**To:** Development Permit Panel  
**From:** Brian J. Jackson, MCIP  
Director of Development  
**Date:** November 22, 2010  
**File:** DP 10-539751  
**Re:** **CENTRO PARKSIDE DEVELOPMENT LTD has applied to the City of Richmond for permission to develop 9651 Alberta Road in order to construct a 22 unit, three storey townhouse development.**

## Staff Report

**RESPONSE TO ITEMS: 9651 Alberta Road [DP 10-539751]**

PROJECT NUMBER: L5  
 SHEET NUMBER: OF 9  
 DRAWING NUMBER: 10539751

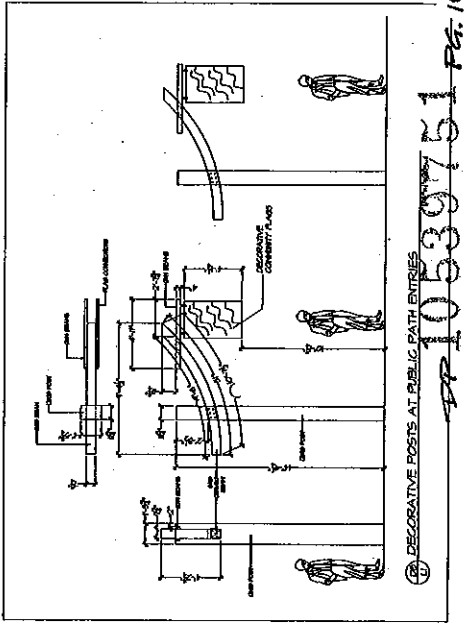
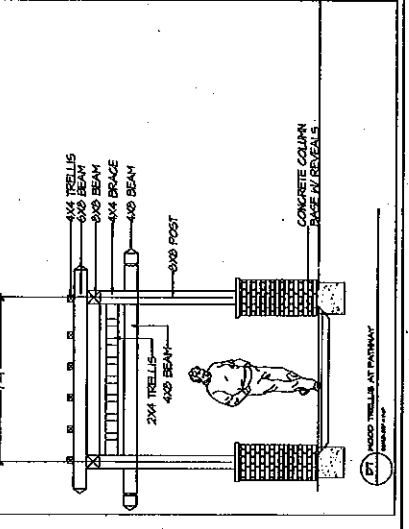
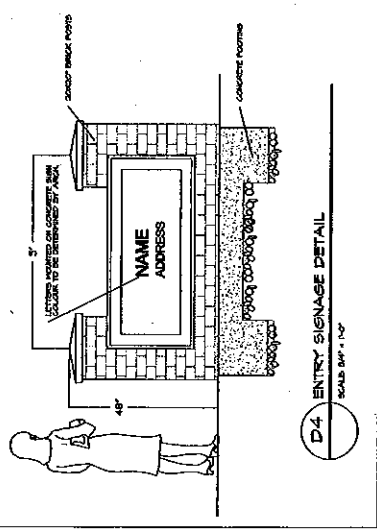
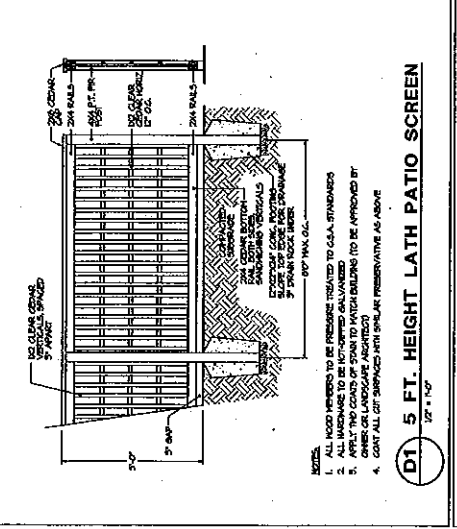
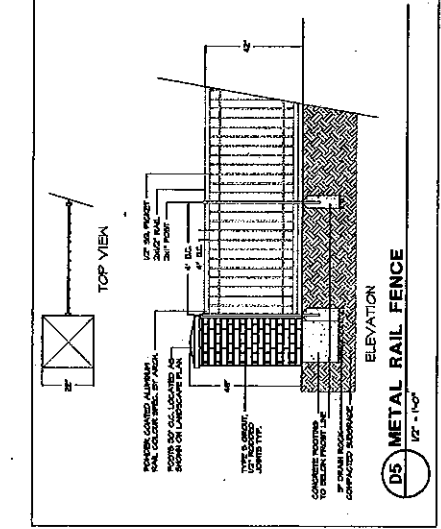
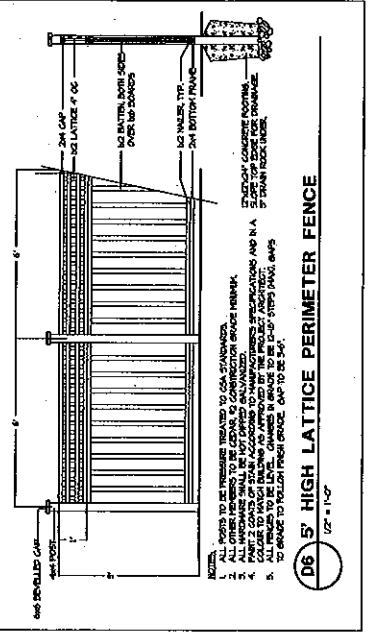
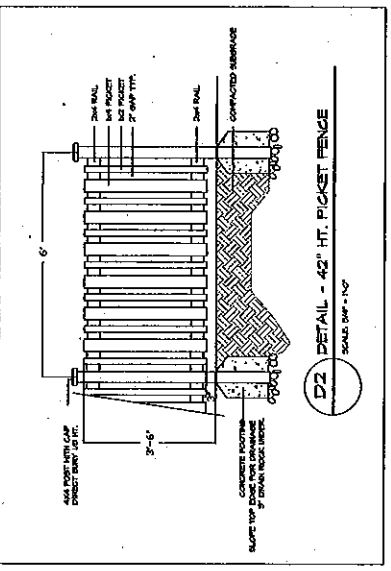
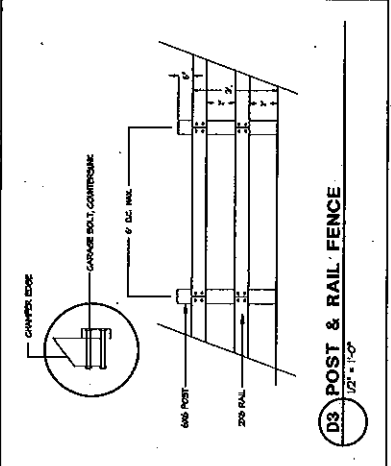
7. consider pursuing the public art process;  
**DMG: Decorative community flag poles have been added next to the pathways on the south and north side. Refer to detail on sheet L5. The detail should be reviewed by the Public Art coordinator for the City.**
